TREE RETENTION PLAN EAST
FOR
PLAT OF TOLT RIVER TERRACE
A PORTION OF NE1/4, OF THE NW1/4 OF THE SE1/4 OF THE SW1/4 OF THE NE1/4 OF SEC. 21 TWP 25 N, RGE 7 E, WM
CITY OF CARNATION, KING COUNTY, WASHINGTON

LANDSCAPE PLAN INDEX
FOR

PLAT OF TOLT RIVER TERRACE

TRT Civils R4 Planset.pdf Markup Summary

Title:
**LANDSCAPE PLAN NW
FOR
TOLT RIVER TERRACE**

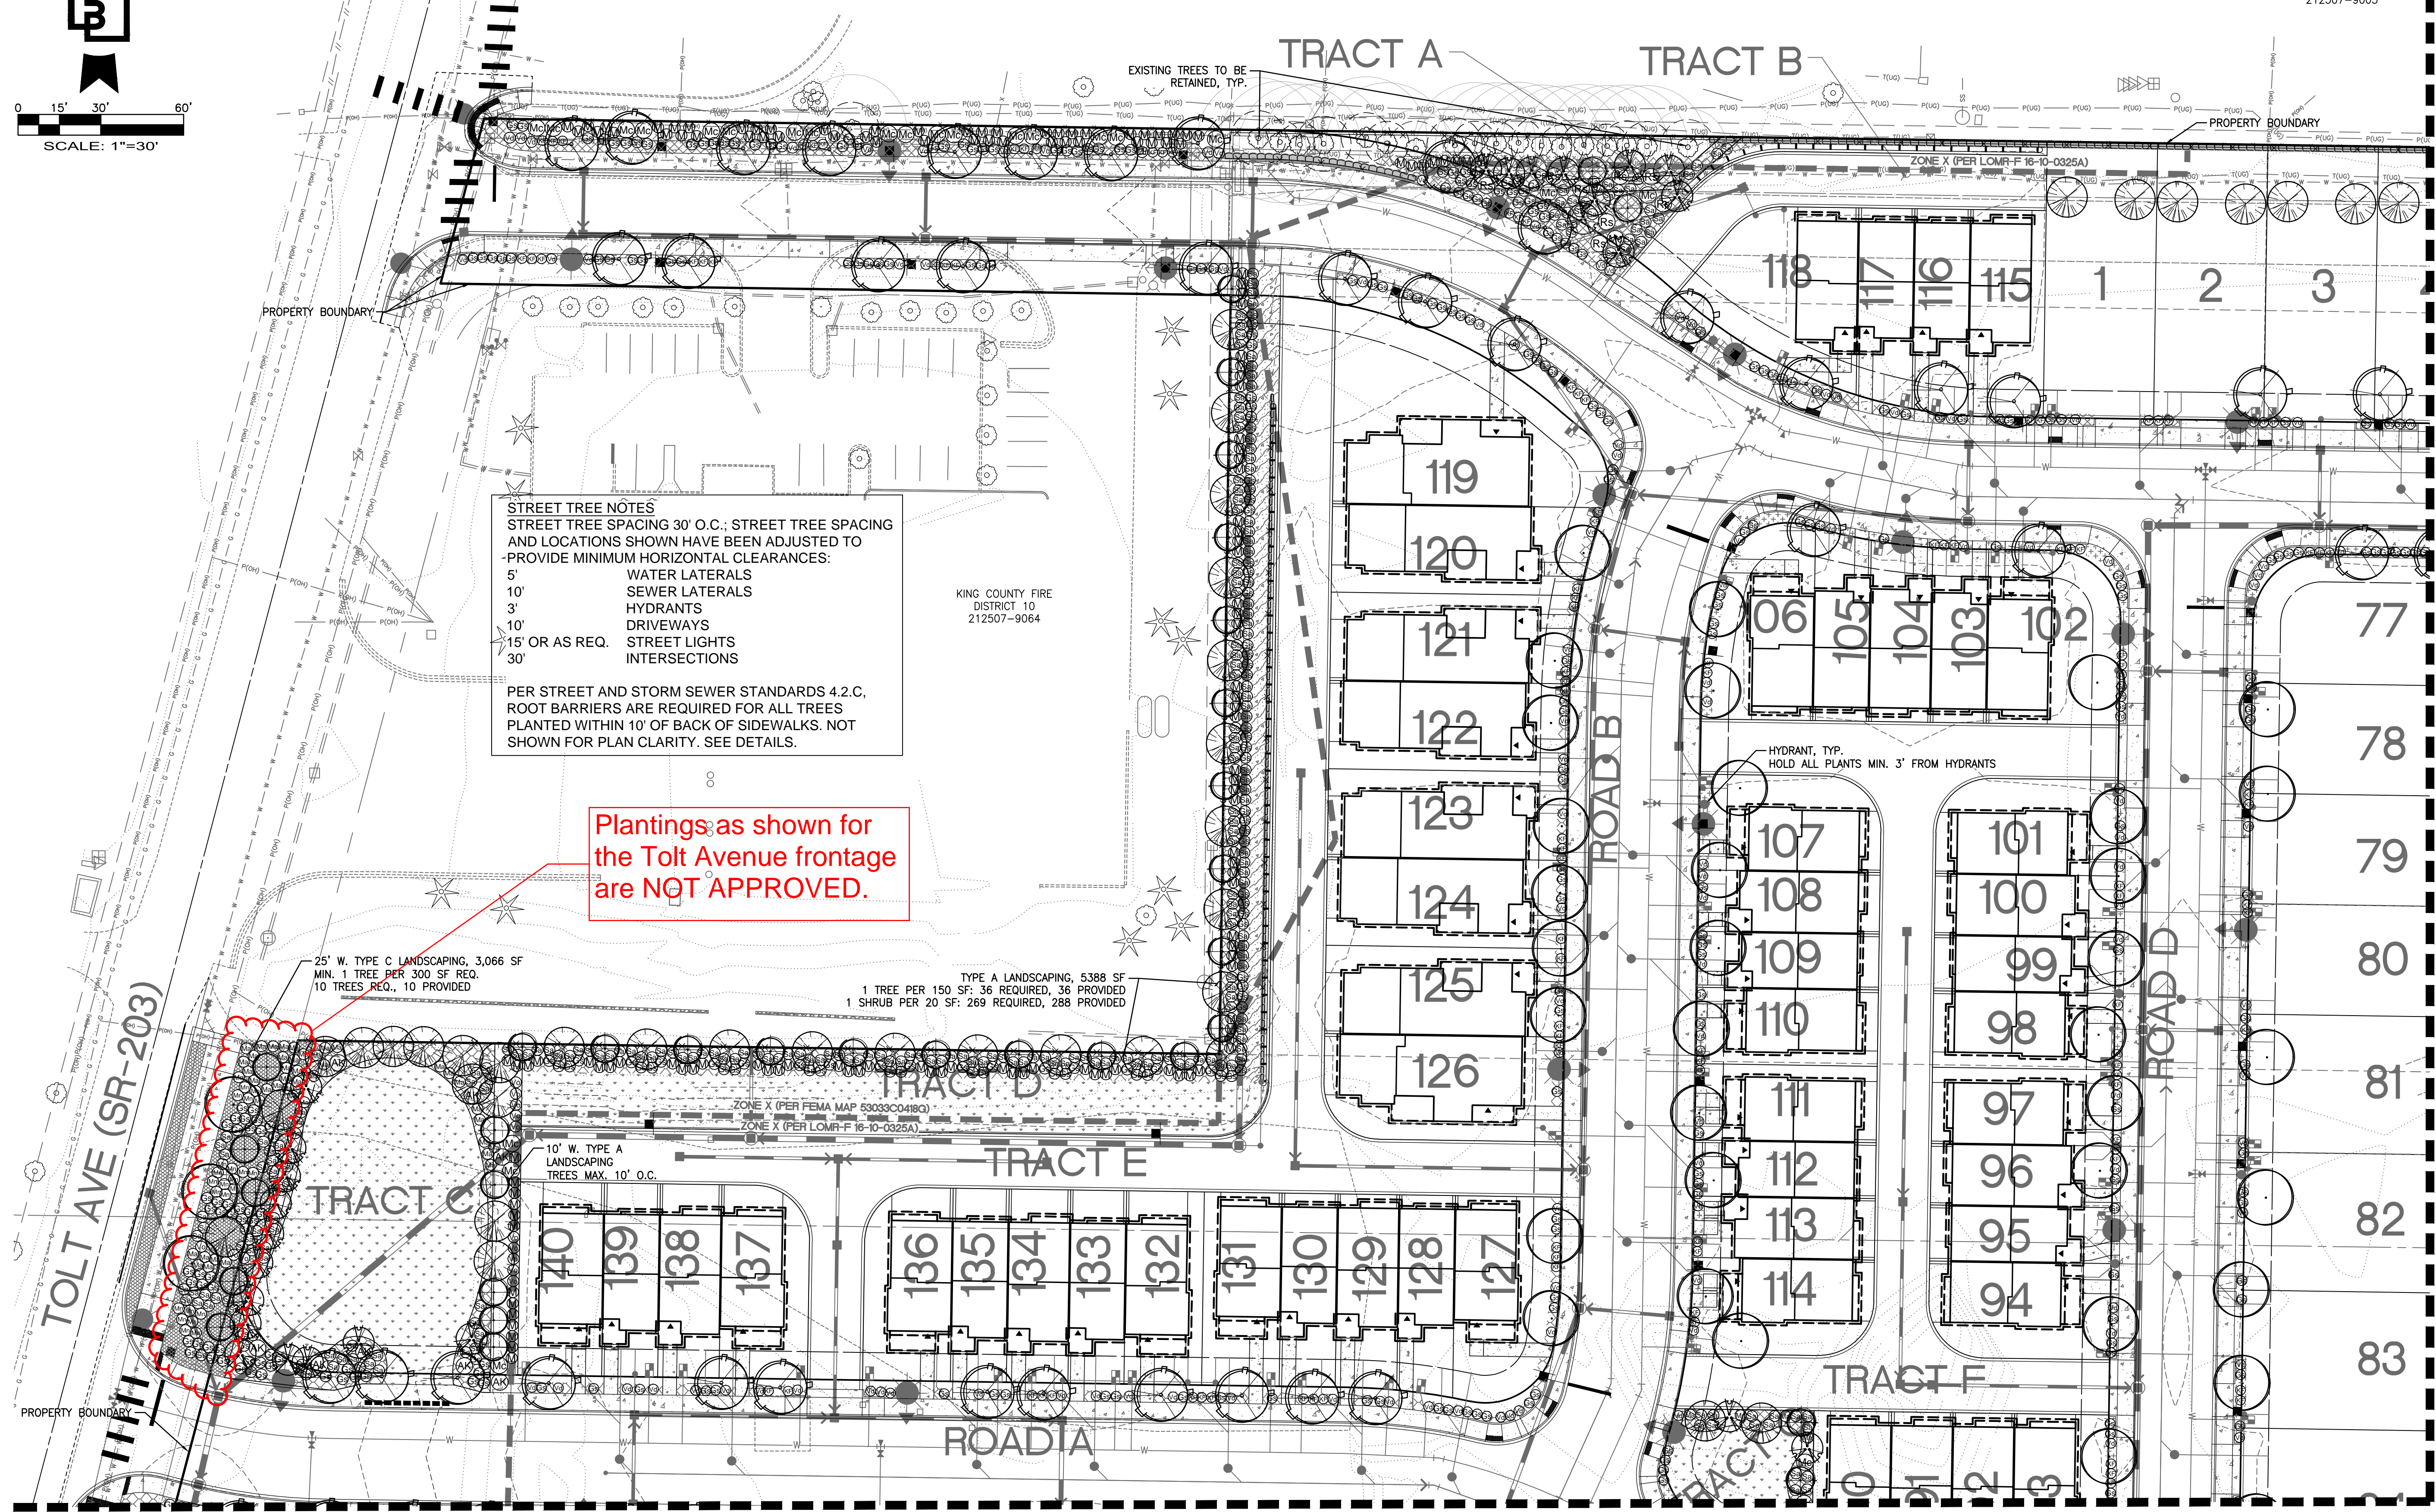
Plantings as shown for the Tolt Avenue frontage are NOT APPROVED.

Title: **LANDSCAPE PLAN SW FOR TOLT RIVER TERRACE**

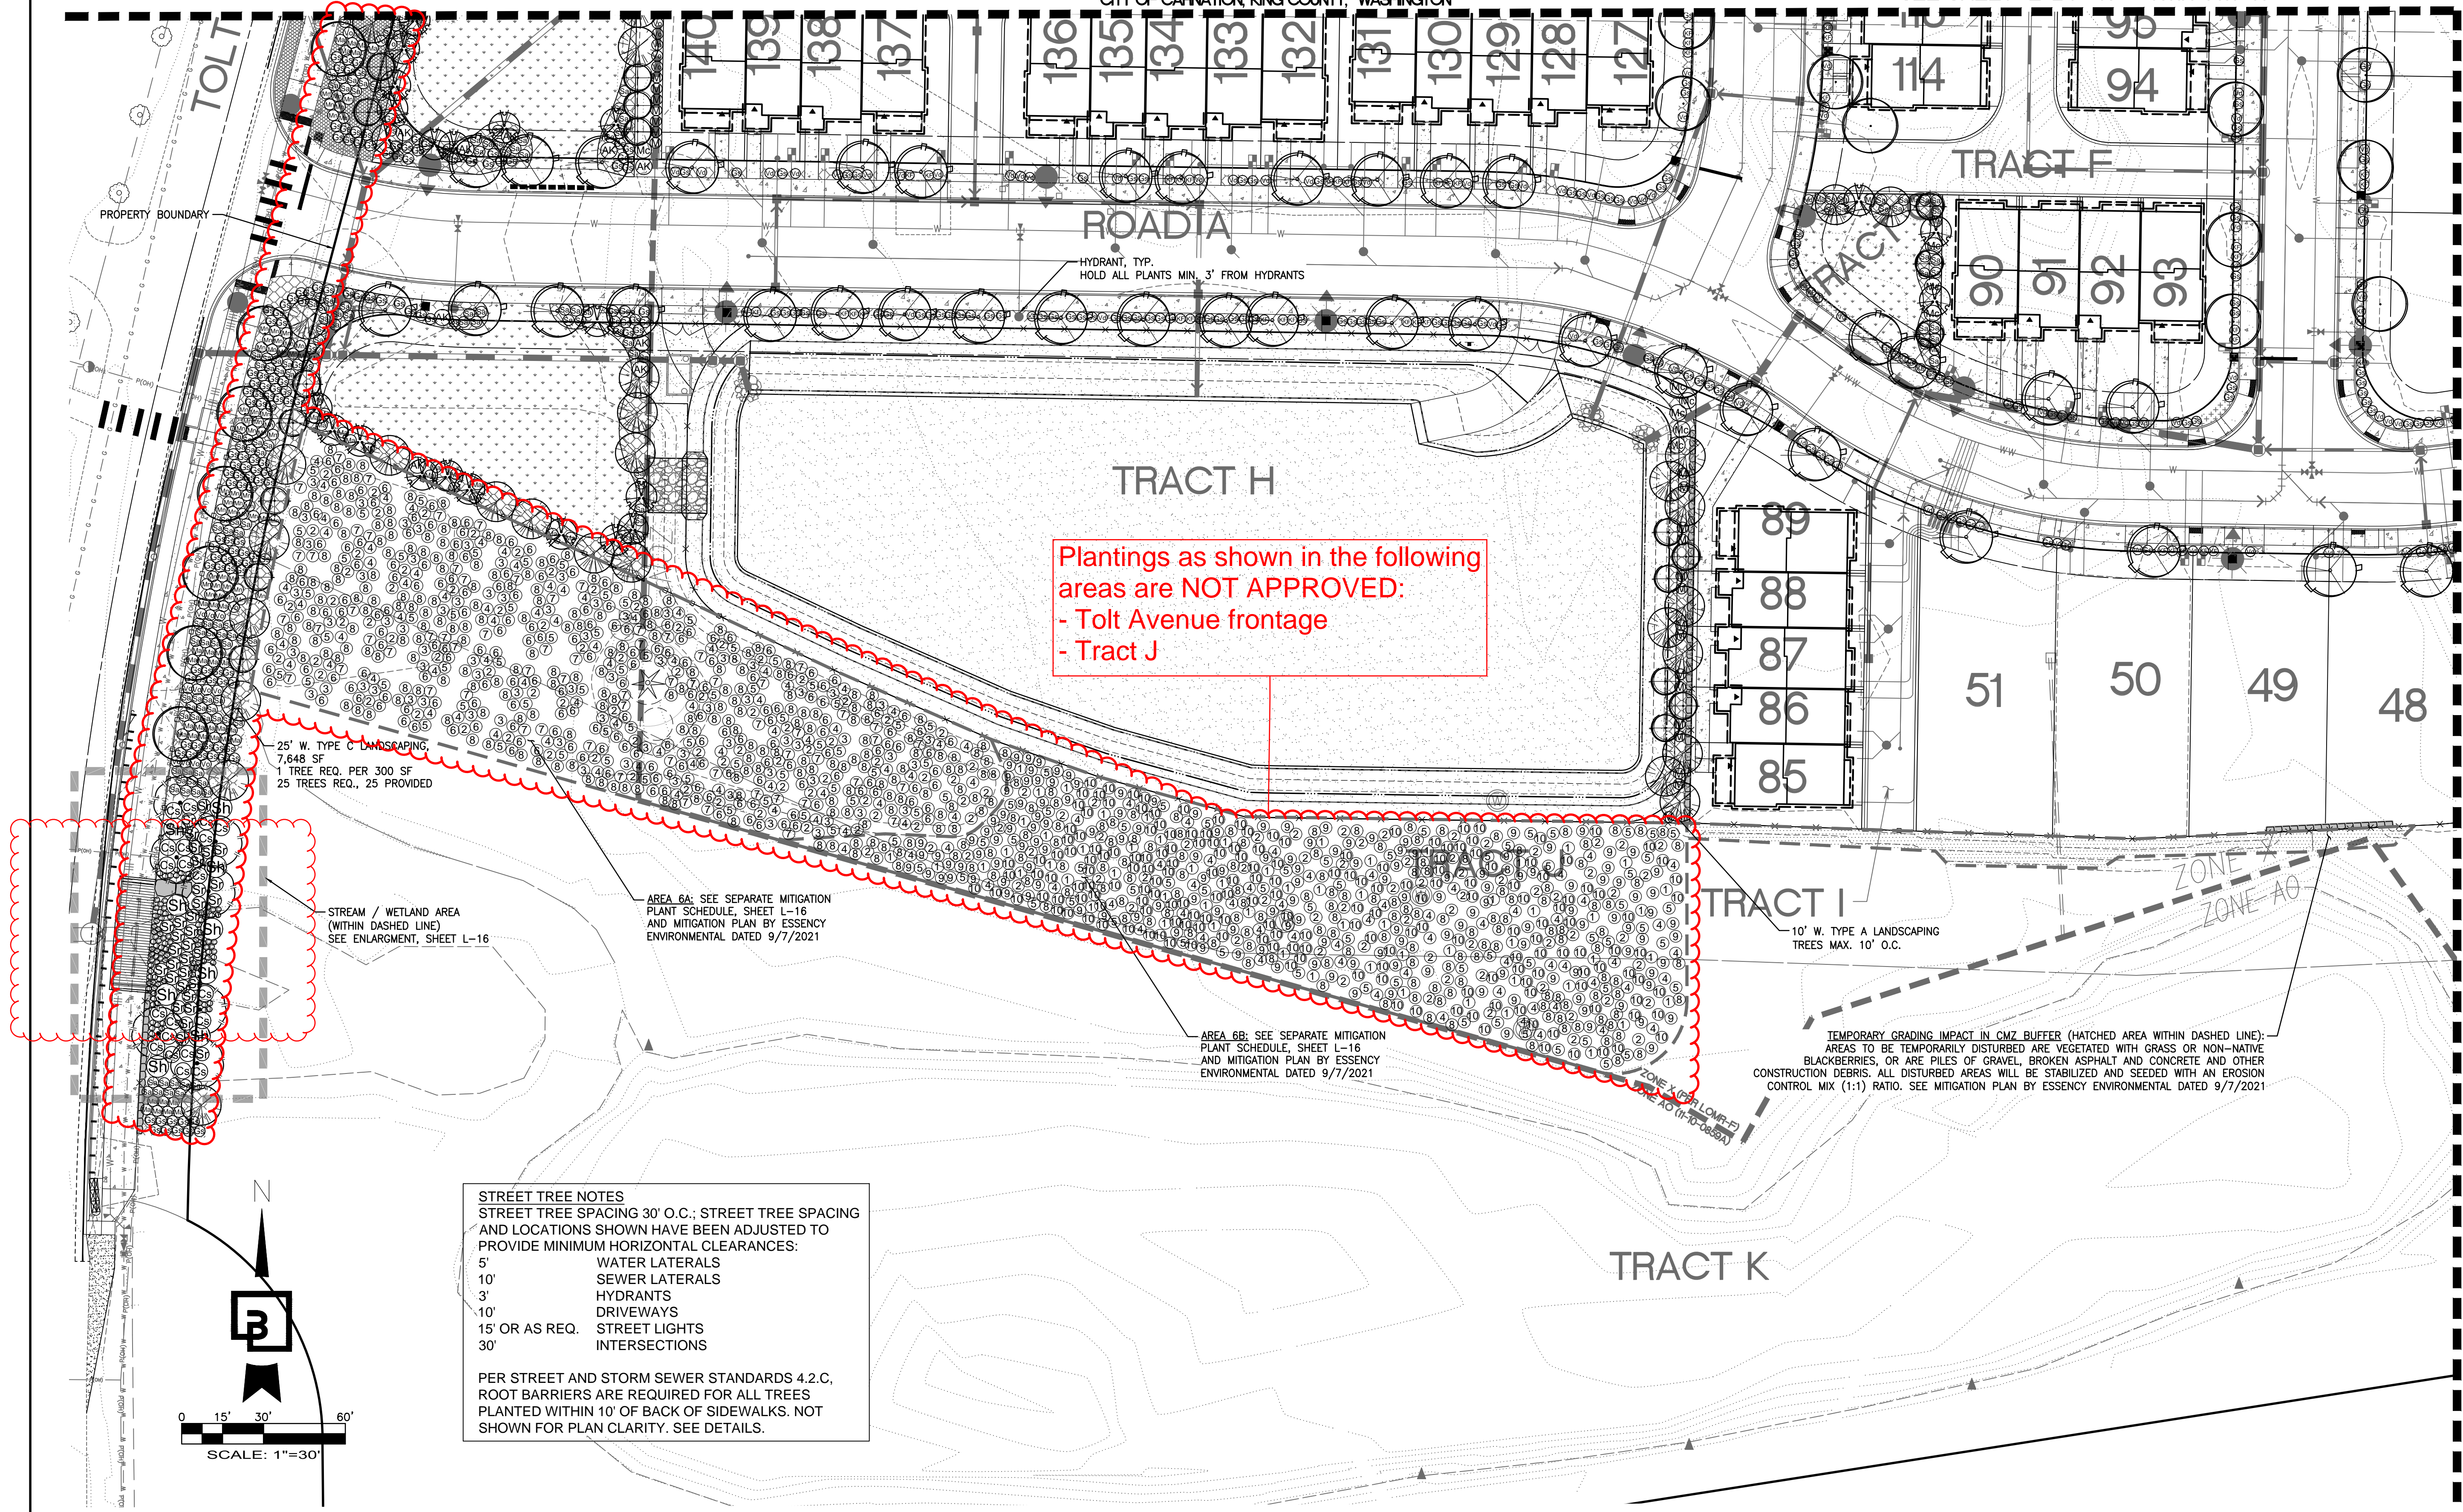
Plantings as shown in the following areas are NOT APPROVED:
- Tolt Avenue frontage
- Tract J

Title: **STREAM AREA ENLARGEMENT AND MITIGATION PLANT SCHEDULE FOR TOLT RIVER TERRACE**

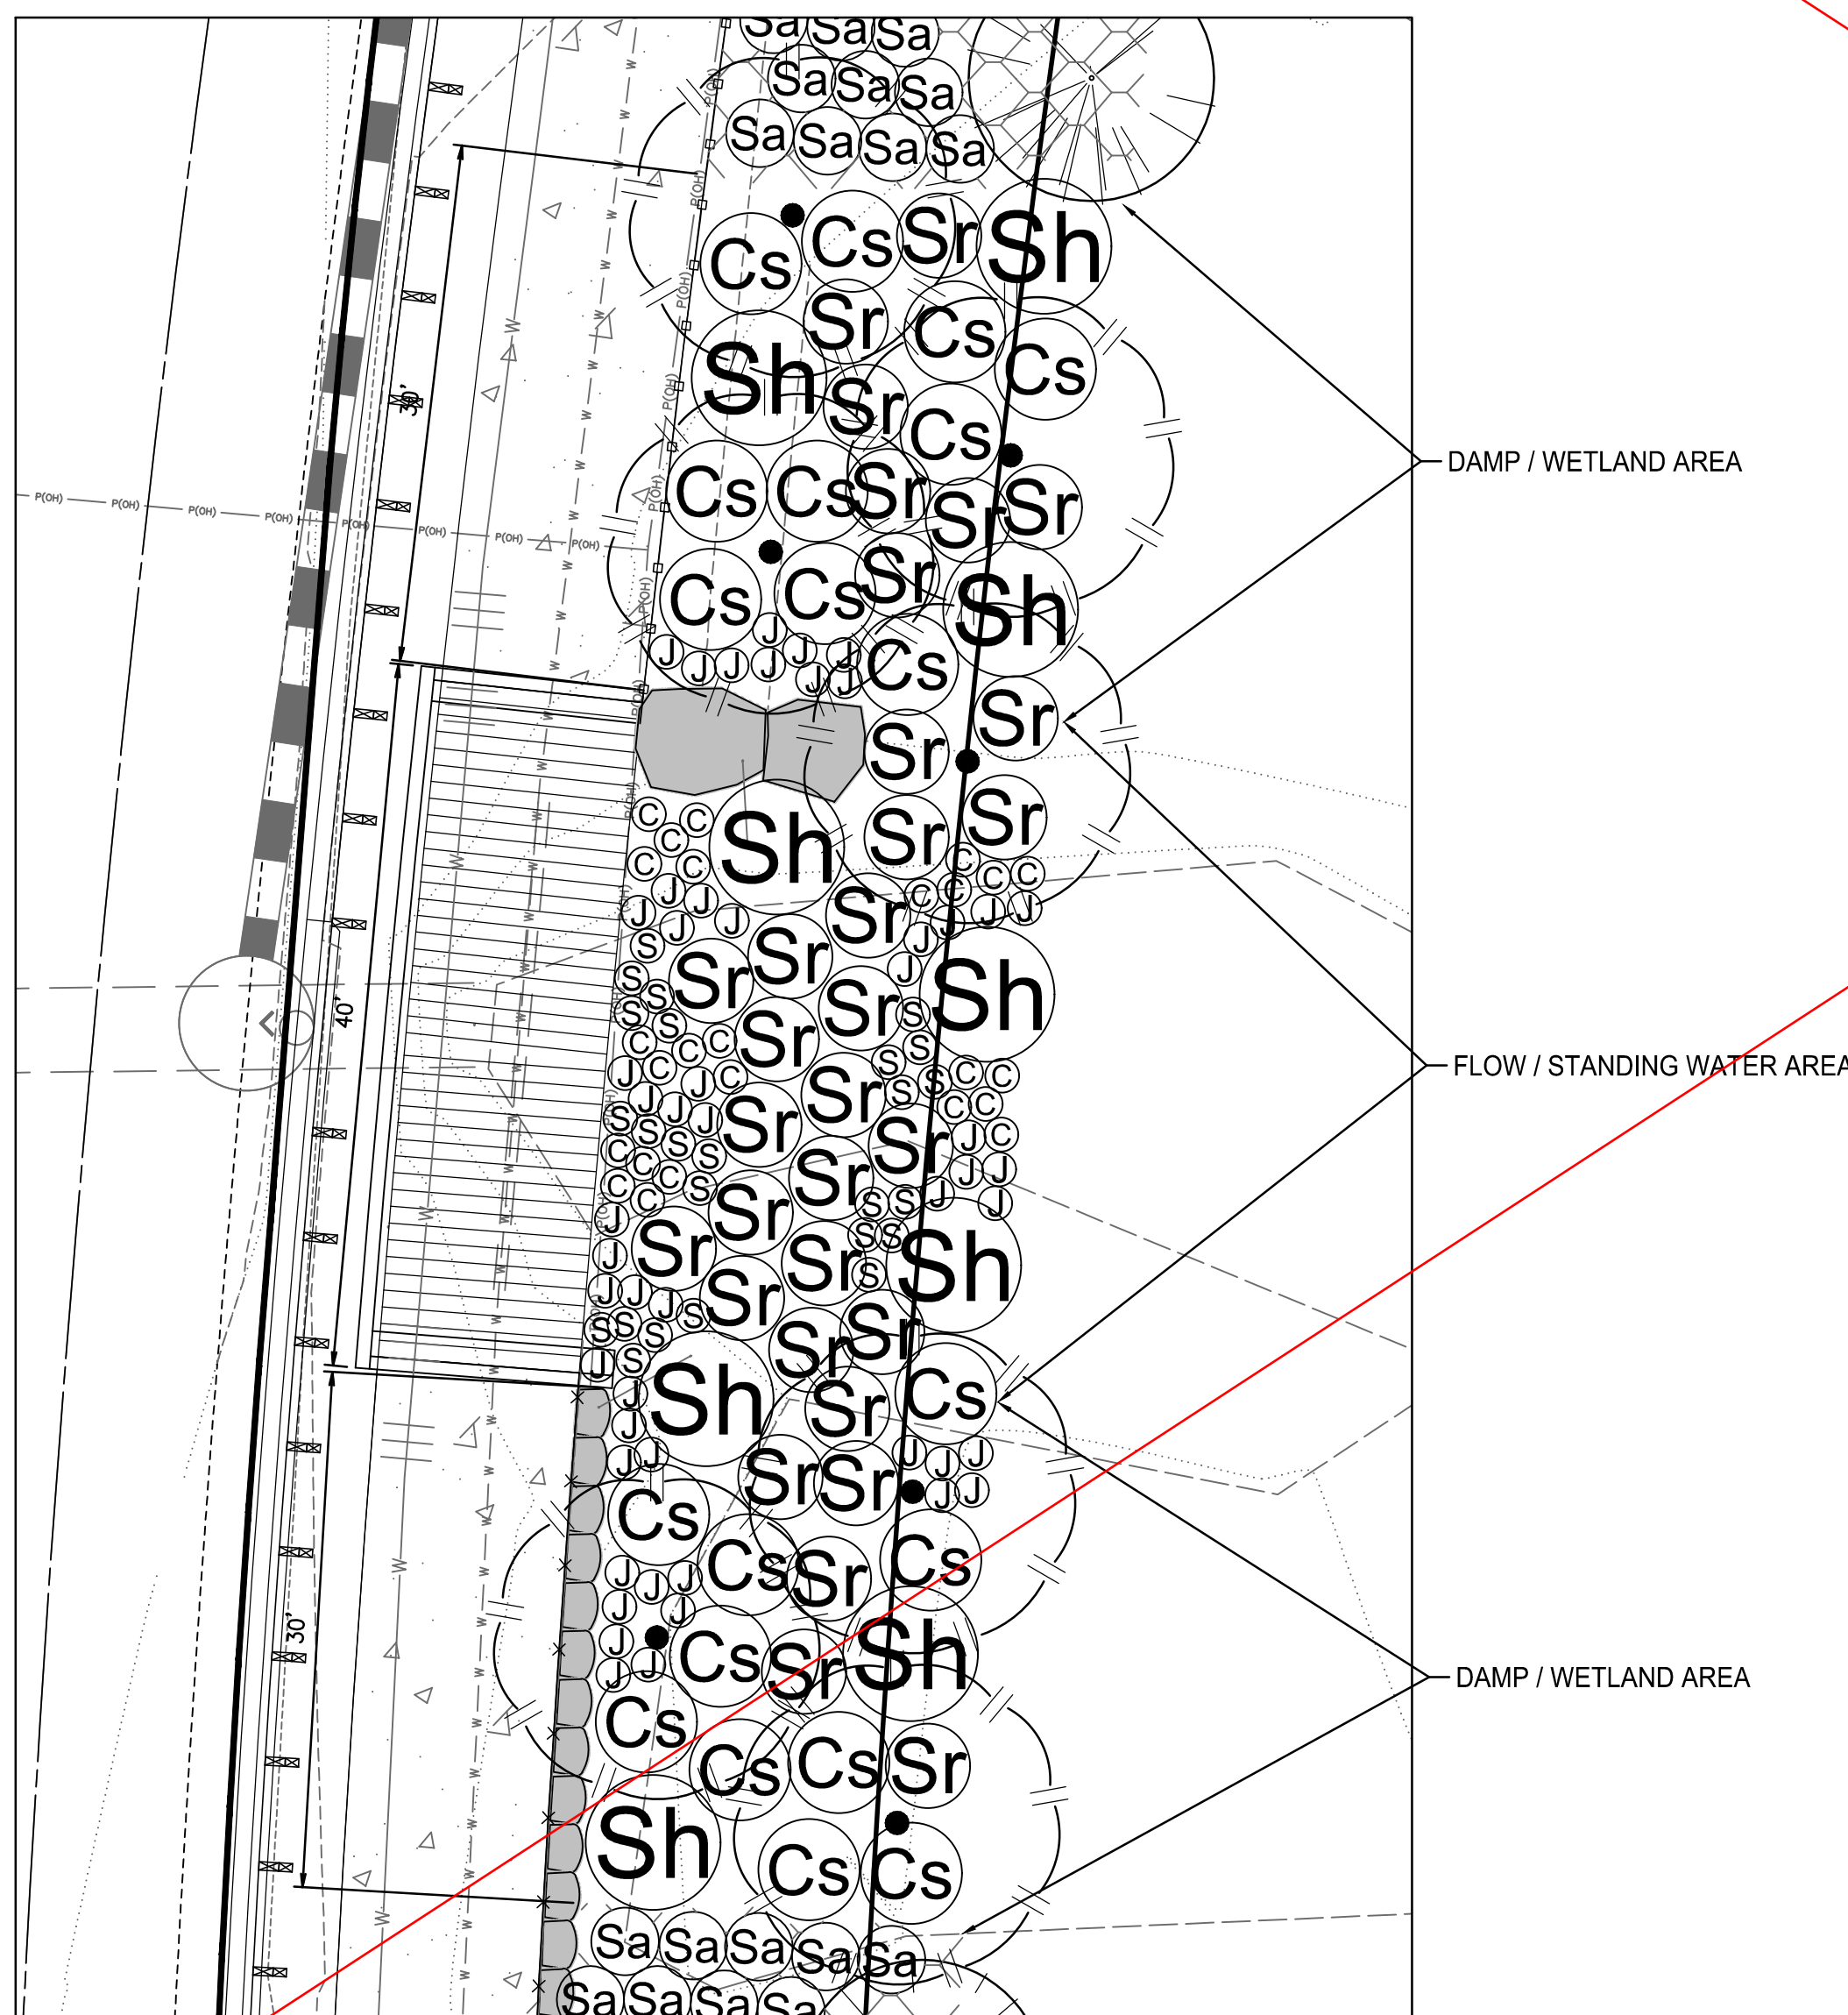
This sheet is NOT APPROVED.
